Docket Item # 3 BAR CASE # 2017-00417

BAR Meeting December 13, 2017

ISSUE: After-the-fact Certificate of Appropriateness to paint unpainted masonry

LOCATION: 404 North Henry Street

Figure 2. 404 and 406 North Henry change in character and composition when one half of a pair is painted.

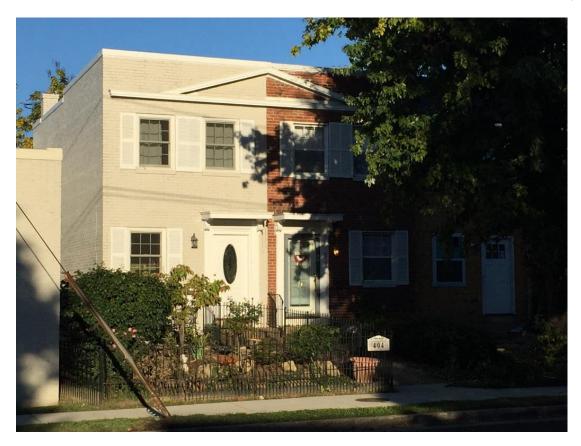
Painting of one unit in a composition is not appropriate, as its impact is not only on the painted rowhouse itself but also the adjacent architectural twin and the overall composition of the row (Figure 2). 424 North Henry Street (BAR Case# 2017-00376) recently requested to paint the exterior of their house to the BAR on October 25, 2017. The request was denied by a vote of 6-0 with the BAR commenting on the overall composition of a row of unpainted units and the potential damage to the brick caused by painting.

The paint at 404 North Henry disrupts the uniform rhythm and relationship of the block. This section of the 400 block of North Henry Street is a cohesive composition and should be interpreted together, all of which are unpainted masonry except 404 North Henry. 404 North Henry is one of a pair that shares a common architectural element (the common pediment) with 406 North Henry and painting one side but not the other significantly diminishes the architectural integrity of both rowhouses. Therefore, the compatibility concern is twofold in this instance: compatibility with the subject property's twin that shares a common pediment and compatibility with the overall row.

Staff finds that changing the color and permanently altering the brick material by painting brick is incompatible and has an adverse effect on the distinguishing original quality of this uniformly red brick blockface. The painting is not historically appropriate and, as explained in the discussion related to the Standards above, staff cannot recommend the after-the-fact painting of unpainted masonry in this location for a number of reasons. However, staff finds that it is less important to remove the paint from the rear elevation which is only visible from an alley. Therefore, staff recommends paint removal from the front and side elevations of 404 North Henry.

Staff recommends **denial** of the application for after-the-fact painting of unpainted masonry. Staff recommends that the BAR require that the applicant remove the paint of the front and side elevations under staff's guidance within six months.
